Hunterdon County Department of Health

Re: Septic System Alteration Waivers
Municipality: Clinton Township
Block: 9 Lot: 5
Location: 4 Hunters Path

TITLE:
 RIVERA RESIDENCE
 INDIVIDUAL SUBSURFACE SEWAGE DISPOSAL SYSTEM
 CLINTON TOWNSHIP HUNTERDON COUNTY, NEW JERSEY

Re: Septic System Waiver Request
Municipality: Clinton Township
Block: 4.03 Lot: 31
Location: 1070 Route 22

SHEET NO.: 1 OF 4

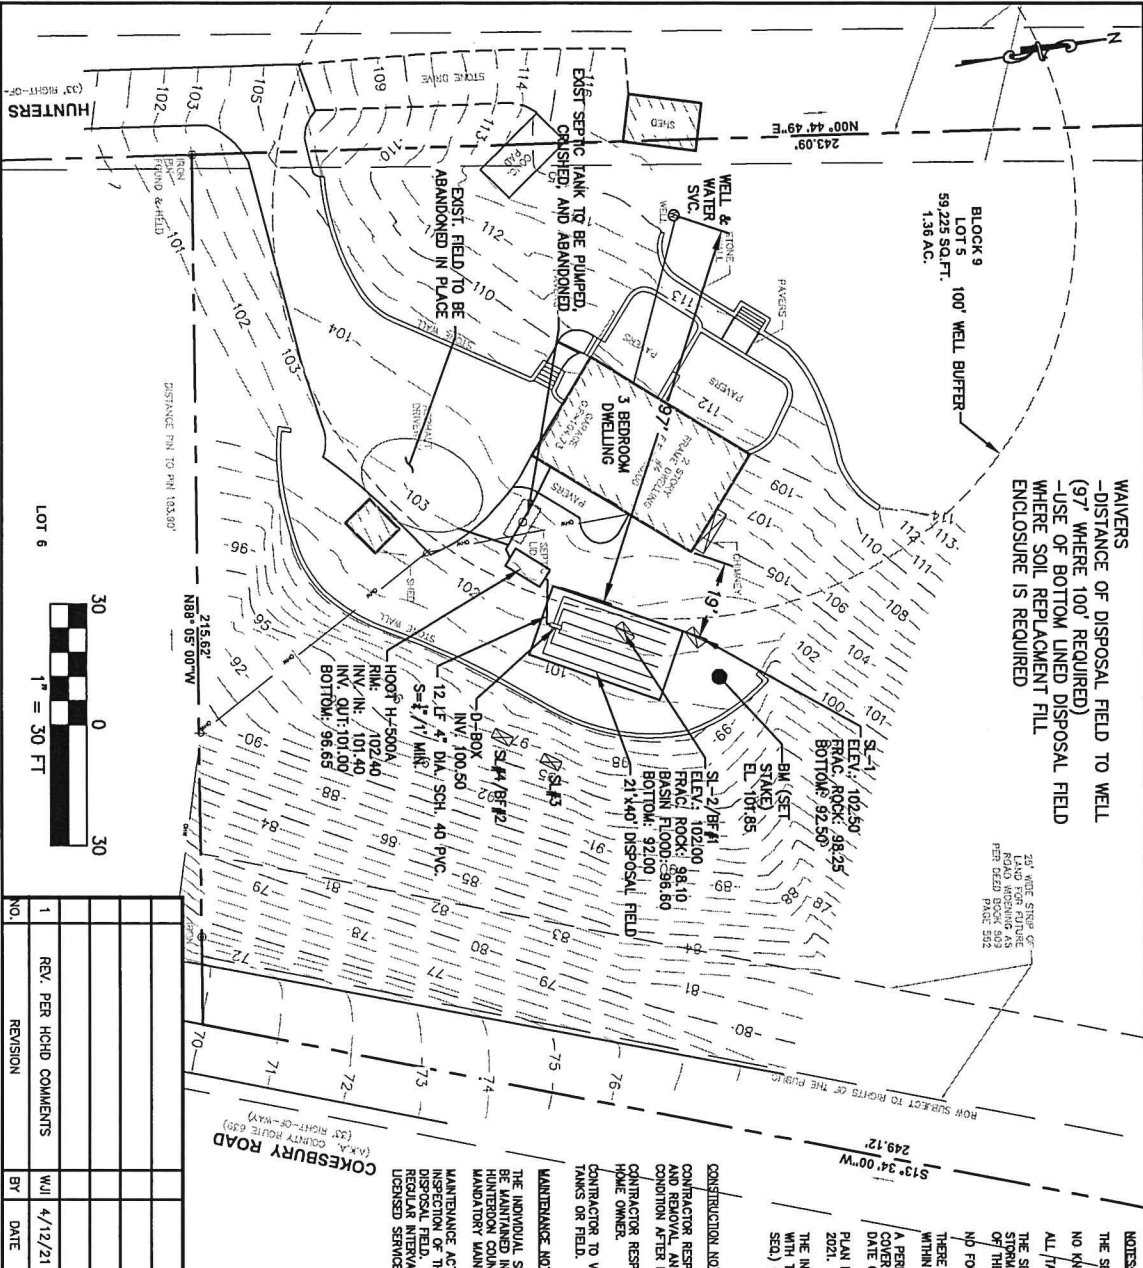
1. The proposed disposal bed will be only 97 feet from the existing well which does not meet the minimum setback requirement of 100 feet. As per 7:9A-4.3 the distance can be reduced to 50 feet provided there is 50 feet of casing. Due to the age of the well and no well record available the engineer has elected to install a Ultra Violet (UV) treatment device on the well for further protection. A water test for coliform will be done after installation of the unit.

2. The proposed system requires a Soil Replacement-Fill Enclosed installation, however due to site limitations the engineer shall explain to the Board why a Bottom-lined installation is proposed.

3. There shall be a minimum of 42 inches of separation from the bottom of the basin flood test pit and proposed level of infiltration. The design proposes only a separation of 35 inches, engineer shall explain why this cannot be done and will not affect the design of the system.

In addition, all requirements for an Advanced Treatment Unit shall be adhered to including signed service agreement for the life of the system, deed restriction, telemetry device, and NEHA certification for the installer which is stated on page 3 of the plot plan.

WAIVERS
 -DISTANCE OF DISPOSAL FIELD TO WELL
 (97' WHERE 100' REQUIRED)
 -USE OF BOTTOM LINED DISPOSAL FIELD
 WHERE SOIL REPLACEMENT FILL
 ENCLOSURE IS REQUIRED

NO.	REVISION	BY	DATE
1	REV. PER HCHD COMMENTS	WJL	4/12/21

SHEET NO.: 1 OF 4

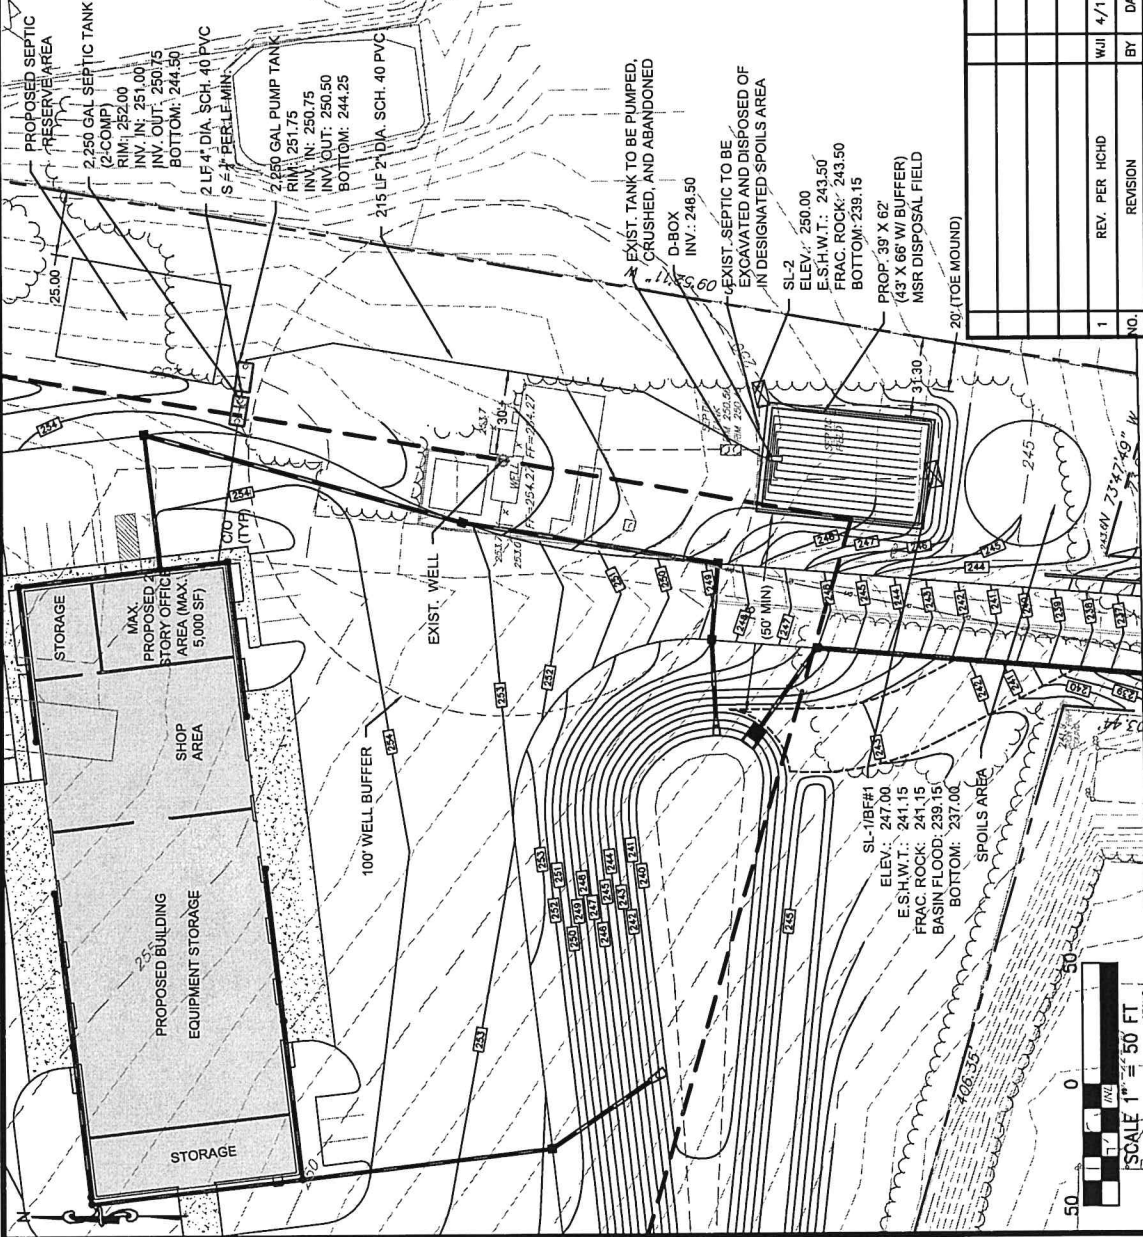
1. The proposed septic tanks, disposal bed and the reserve area are all outside the building envelope.

NO.	REVISION	BY	DATE
1	REV. PER HCHD	WJI	4/12/21
